DEPARTMENT OF ENVIRONMENTAL PROTECTION SITE REMEDIATION AND WASTE MANAGEMENT PROGRAM

Approval Letter: Response to NJDEP Comments – Site Investigation Summary PowerPoint Presentation Response to Comments (November 20, 2020 Comments)

RE: Amerada Hess Corp- Former Port Reading Refinery
EPA ID No. NJD045445483
750 Cliff Road
Woodbridge Twp, Middlesex County
PI#: 006148

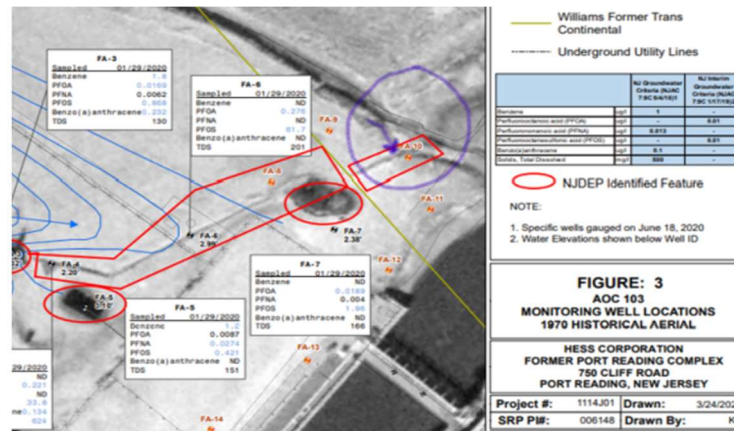
- Bullet 1: The response is conditionally accepted. Please confirm whether monitoring well FA-10 (see circle and arrow) is in the drainage area (darkened area on figure). Future discussion regarding this matter should be addressed through the 2021 Marine Area RIW correspondence.
